# **City of Round Rock**

# **Planning and Zoning Commission**

# **Meeting Agenda - Final**

Wednesday, April 15, 2015 7:00 PM City Council Chambers, 221 East Main St.

# Kenney Crossing FINAL PLAT FP1501-006

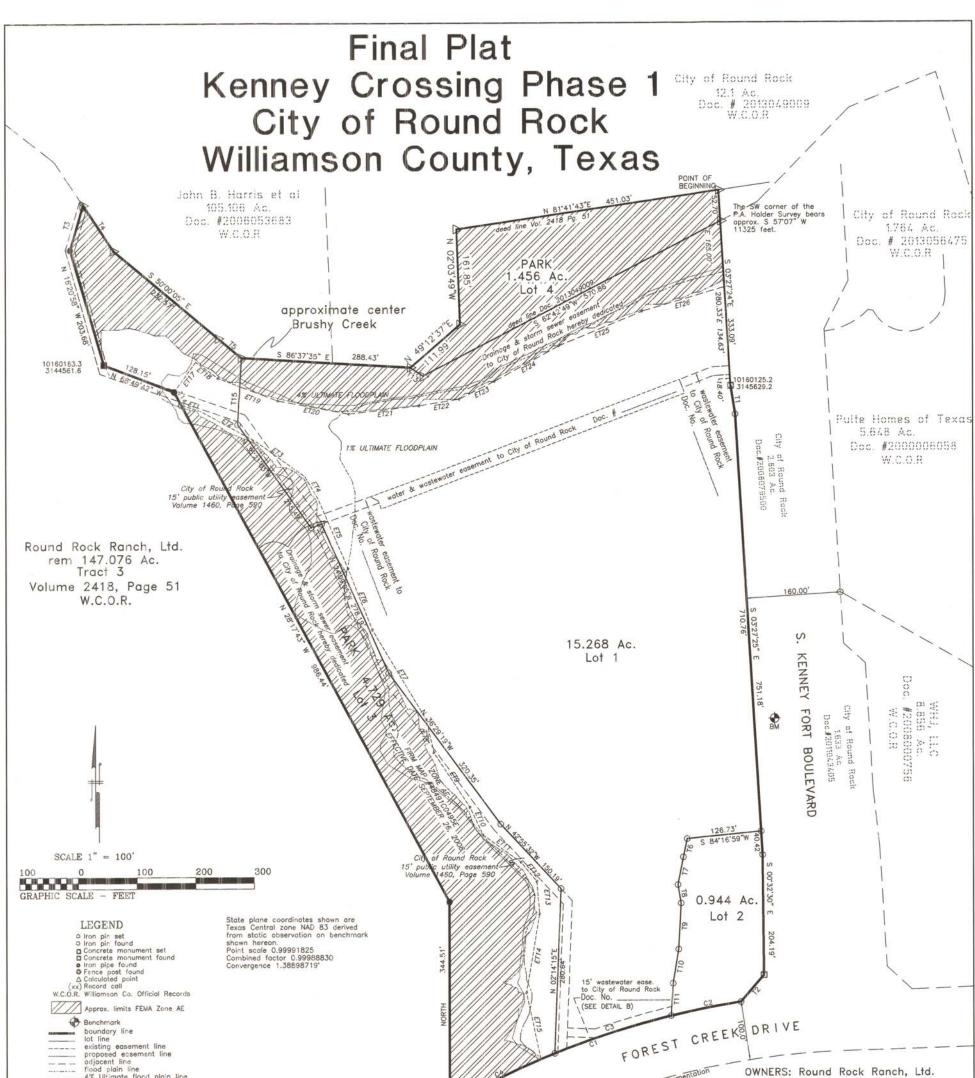
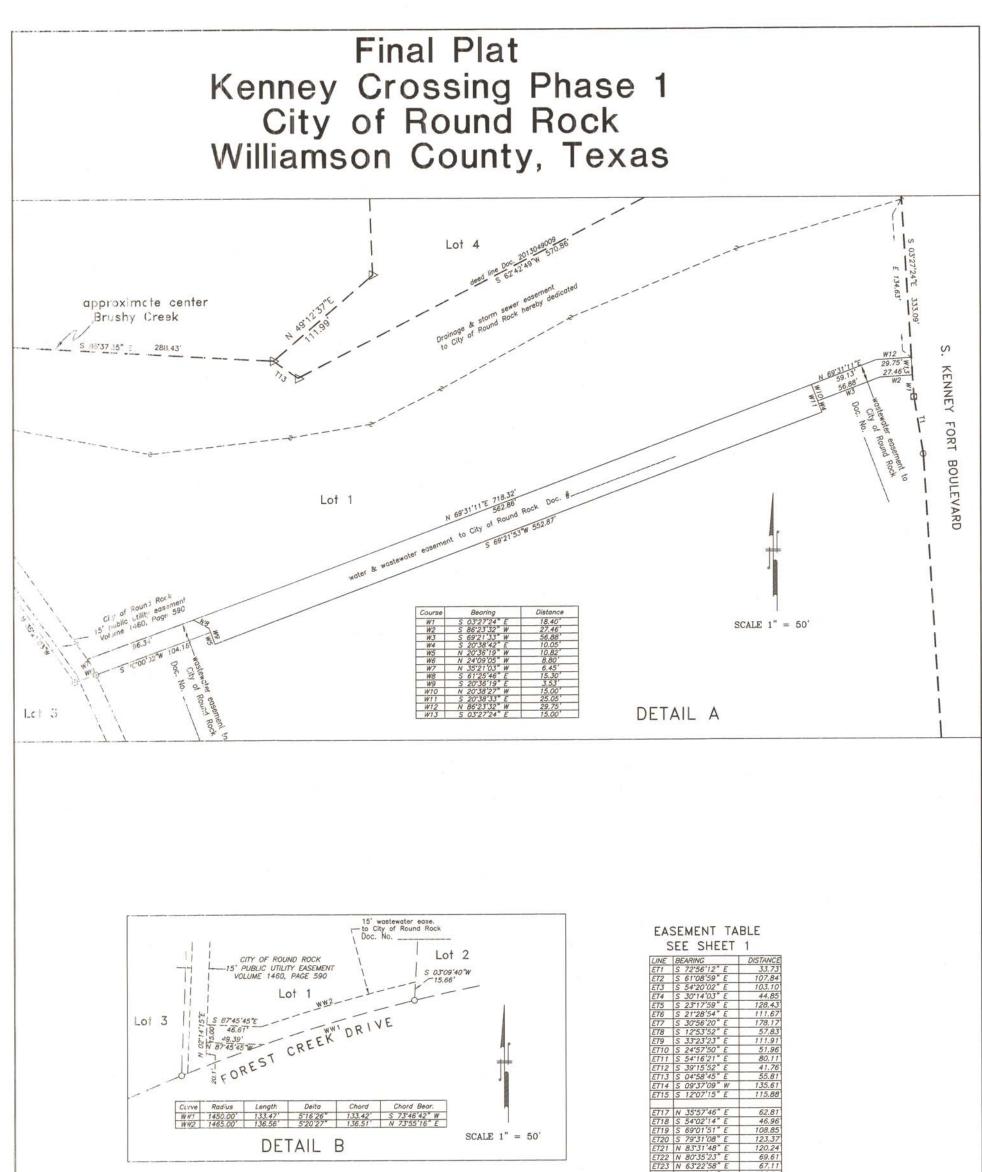
- 1. Provide space for document numbers on water and wastewater easements. (Waterline Easement Doc. No. \_\_\_\_\_)
- 2. Clarify limits of drainage and storm sewer easement for ultimate 4% annual chance floodplain by providing arrows or some way to clarify where the limits are located.

# Kenney Fort Sec. 2 FINAL PLAT FP1503-005

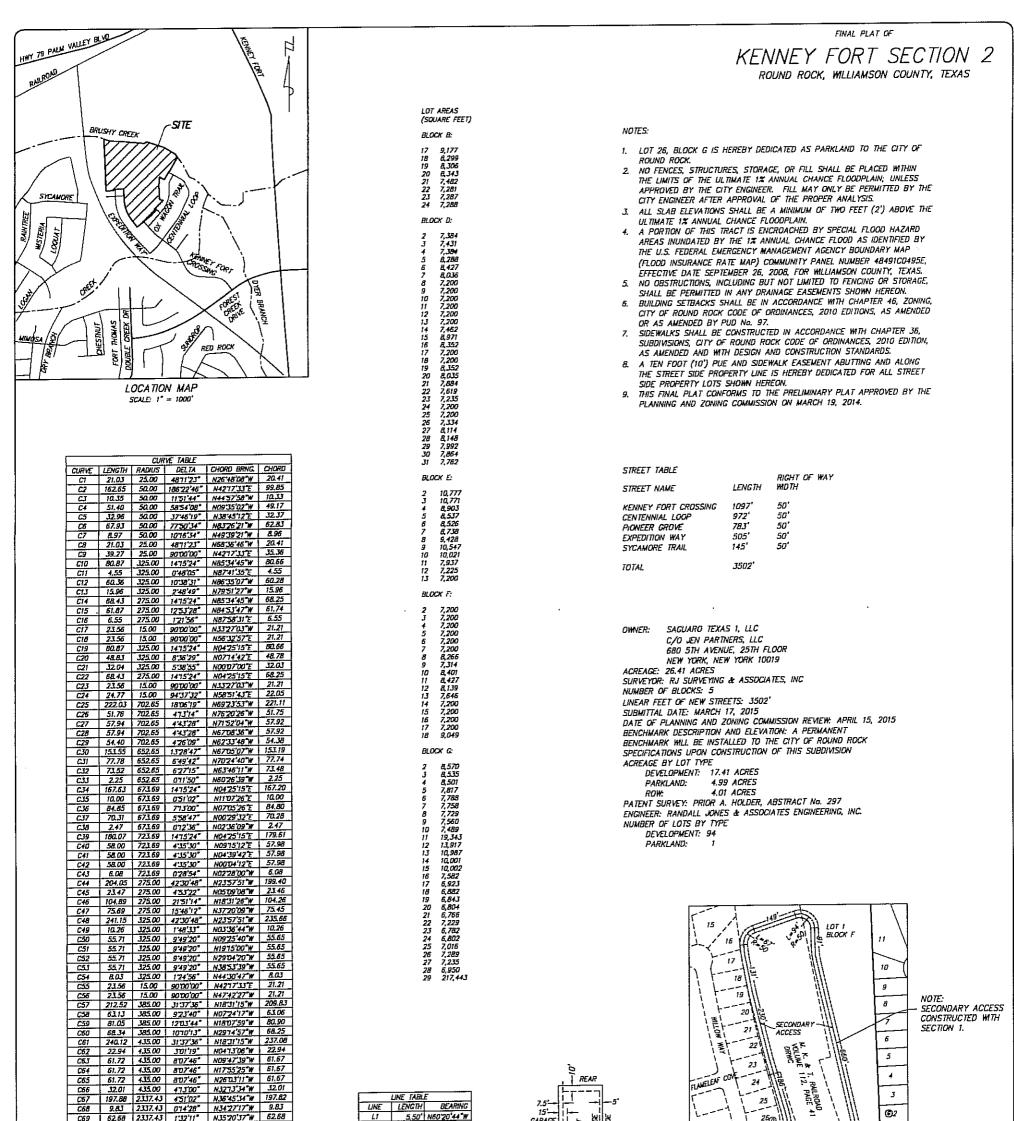
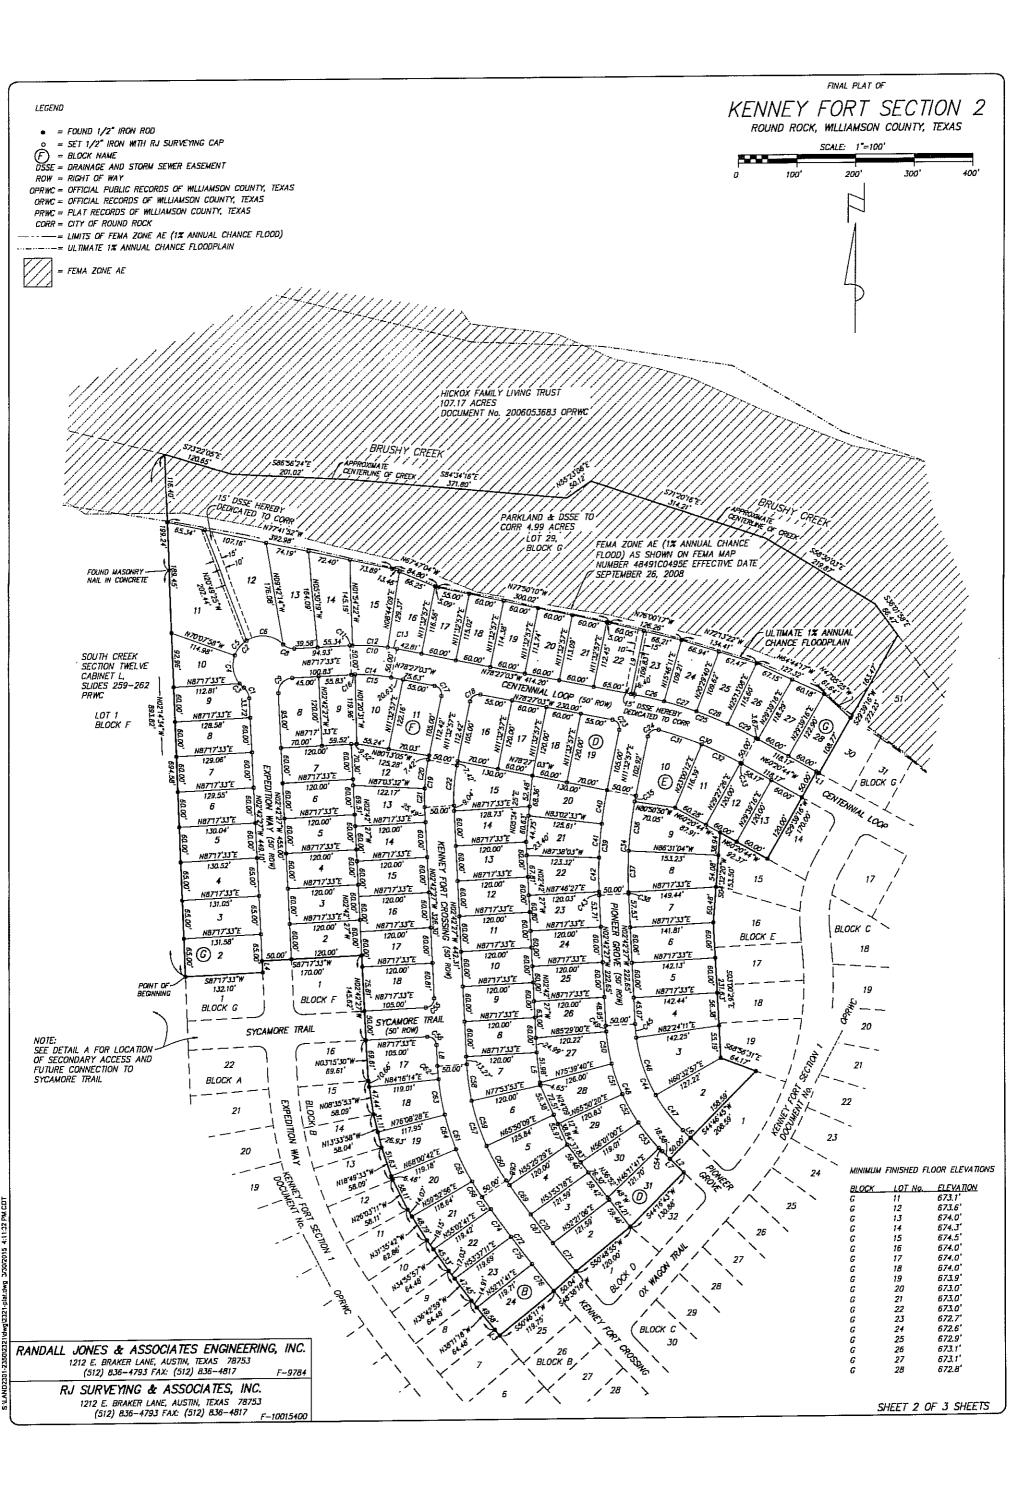
- 1. Note #1 and the parkland label on Lot 26, Block G will be updated to provide "Document No.\_\_\_\_\_" to allow for the separate instrument dedication to be shown on the plat.
- 2. Benchmark note to be provided with closeout of Kenney Fort, Section 1.
- 3. Lots 11 and 23, block G easement callouts shall be "15' DSSE Doc #\_\_\_\_\_".

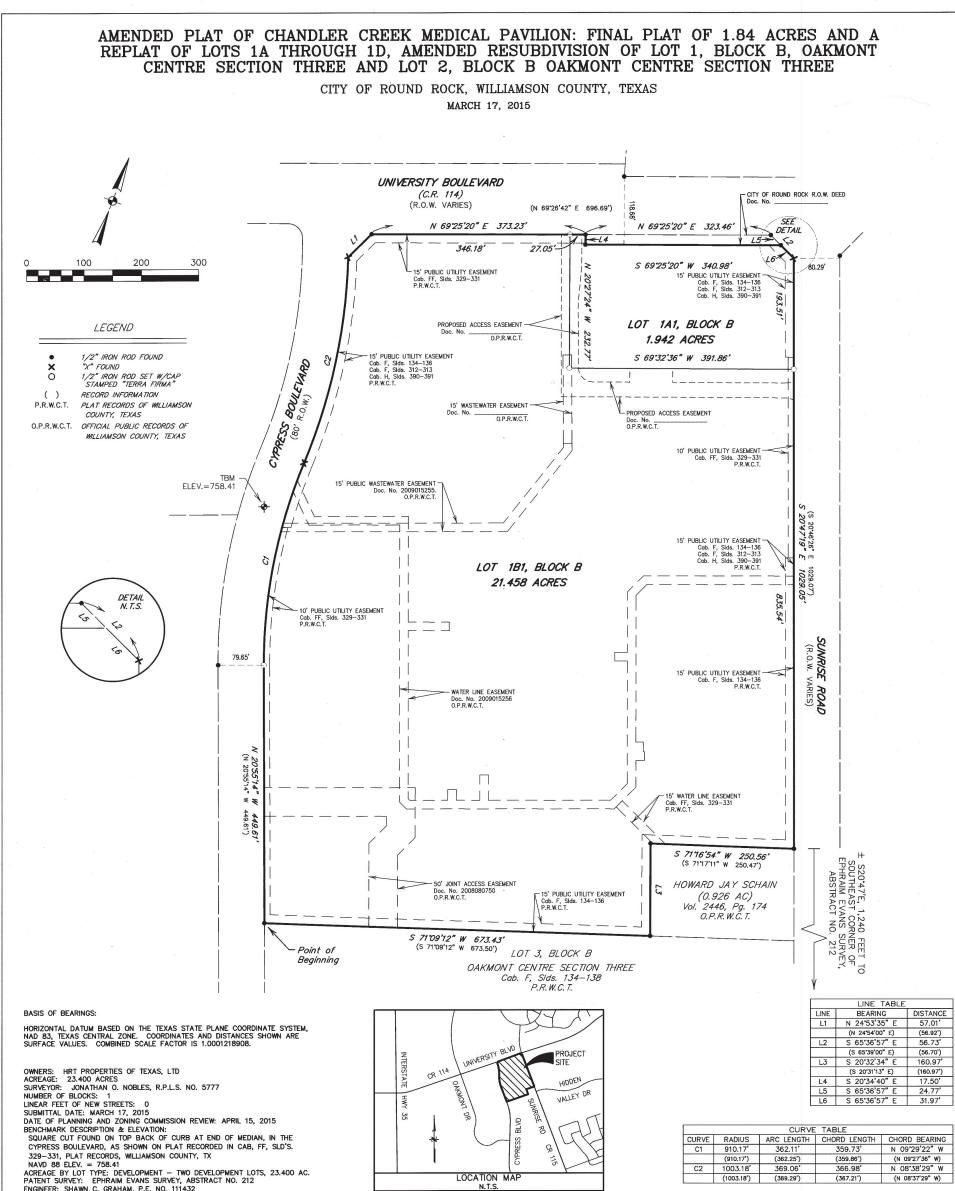
- 1. Depict the existing PUE along University Blvd.
- 2. Add the document numbers for the recorded plats referenced in the title.

# Freeman Park Subdivision - Phase 4 FINAL PLAT FP1503-003

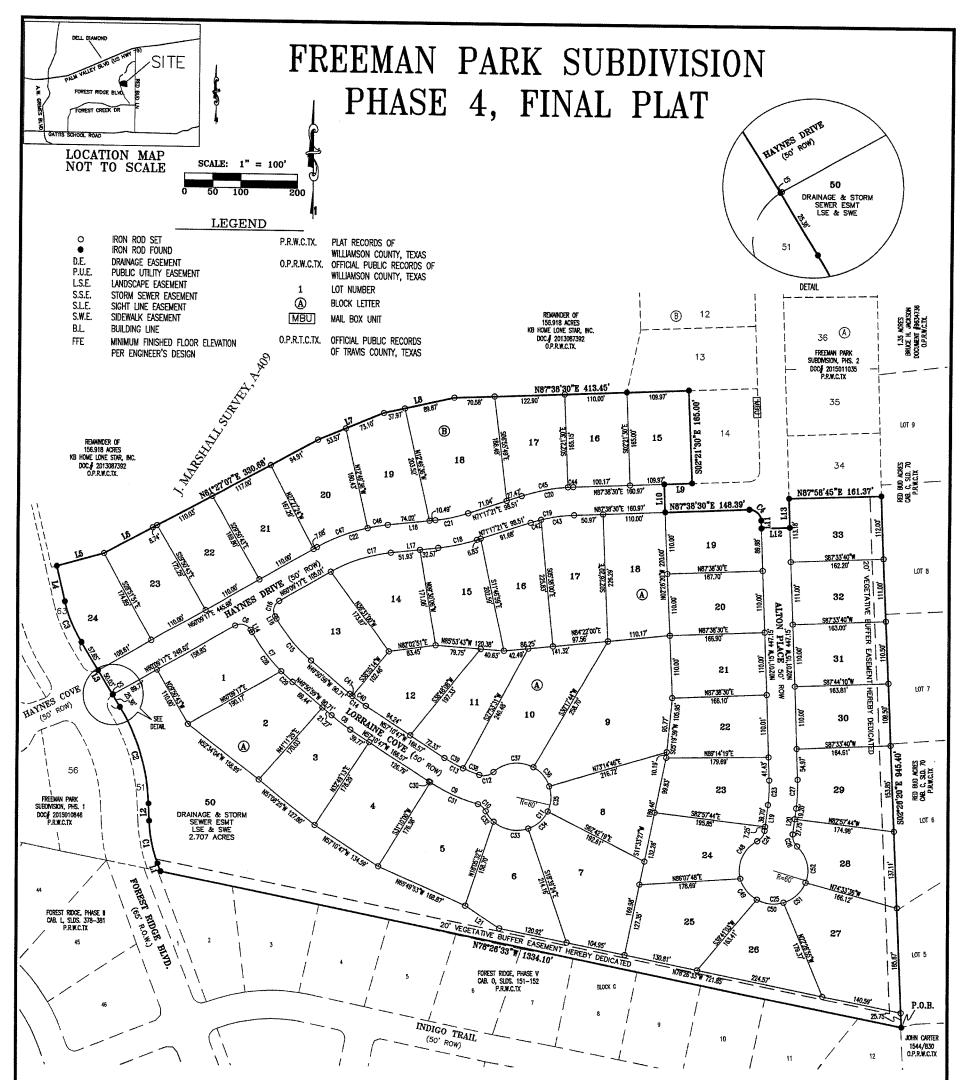
1. Provide an updated tree survey prior to recordation.

- 2. Remove PUE/Sidewalk note #4 and indicate location on the plat schematic. For monarch tree conflict locations, the PUE cannot encroach the critical root zone.
- 3. Update benchmarks to be permanent instead of temporary prior to recordation.
- 4. Call out all proposed/existing easements. (Ex.: 20' LSE/SWE/PUE along Forest Ridge Blvd.)
- 5. Provide the Planning & Zoning Commission review date in the plat synopsis.
- 6. Update note 7 to begin "this tract is not".
- 7. Note #6 will be updated to indicate the Preliminary Plat update.
